MIL-C-38373B
AMENDMENT 2
21 October 1985
SUPERSEDING
AMENDMENT 1
20 Jan 1978

MILITARY SPECIFICATION

CAP, FLUID TANK FILLER

This amendment forms a part of Military Specification MIL-C-38373B, dated 1 Jul 1975, and is approved for use by all Departments and Agencies of the Department of Defense.

FIGURE 5. Lanyard-to-cap attachment.

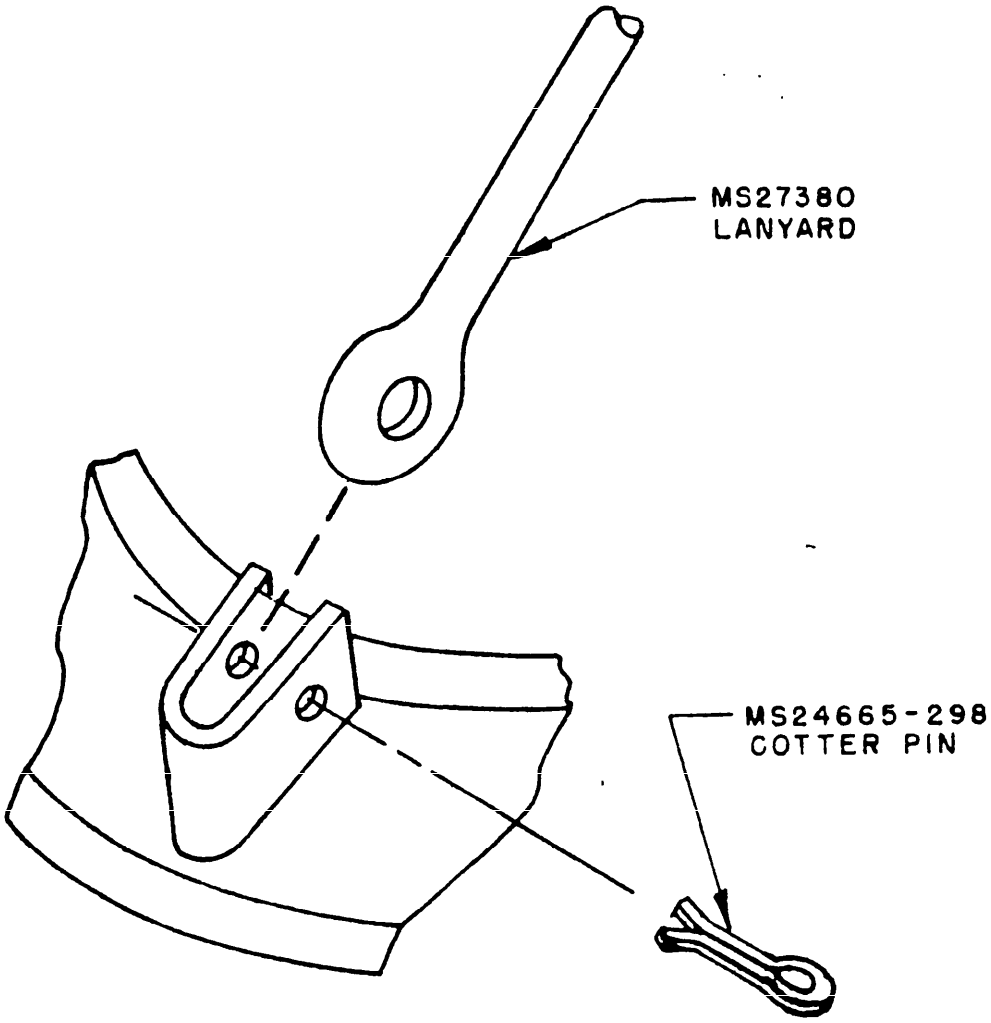
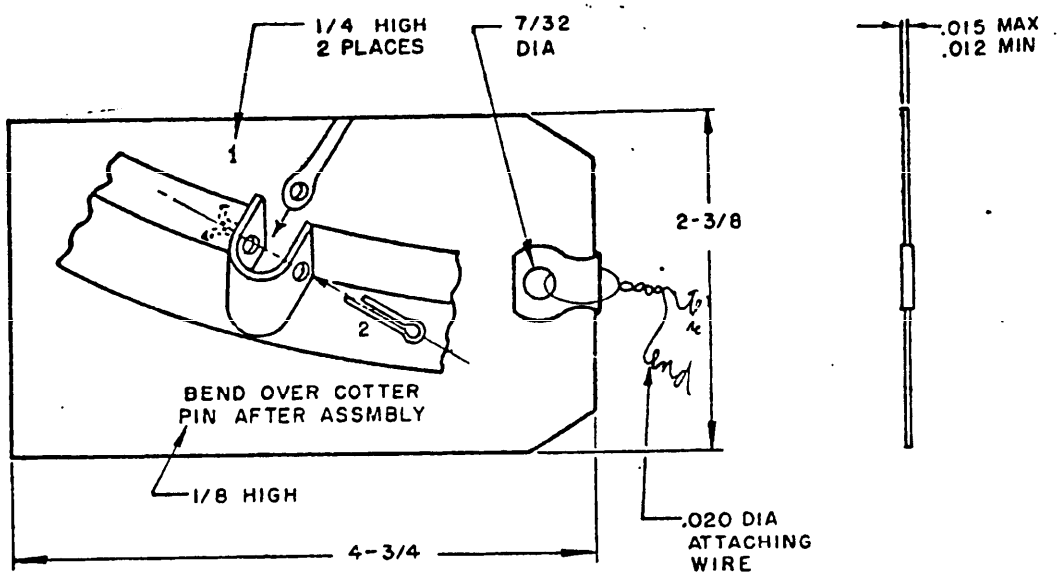
a. Type III class A caps - Polyurethane lanyard in accordance with MS27380 with lanyard-to-cap attachment provisions as shown on figure 5.

"3.5.6.1 Replacement of chain or lanyard. The time required to remove and replace the chain or lanyard shall not exceed 5 minutes using standard tools. It shall be possible to accomplish this replacement without disturbing the factory adjustment of the latching mechanism. For type III class A caps, the lanyard-to-cap attachment shall be by means of an MS24665-298 cotter pin as shown on figure 5."

Add FIGURE 5: Figure 5 forms page 4 of this amendment.

FIGURE 6. Lanyard attachment instruction tag.

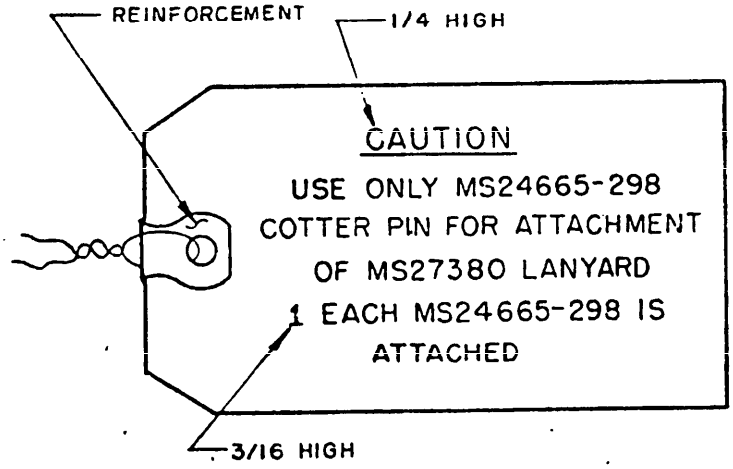
"NOTE: Attachment lanyards or chains are not included as part of cap assembly. One each MS24665-298 cotter pin will be furnished with all type III class A caps. During shipment the cotter pin will be attached to the cap along with a shipping tag in accordance with figure 6."

*Add Figure 6: Figure 6 forms page 5 of this amendment.
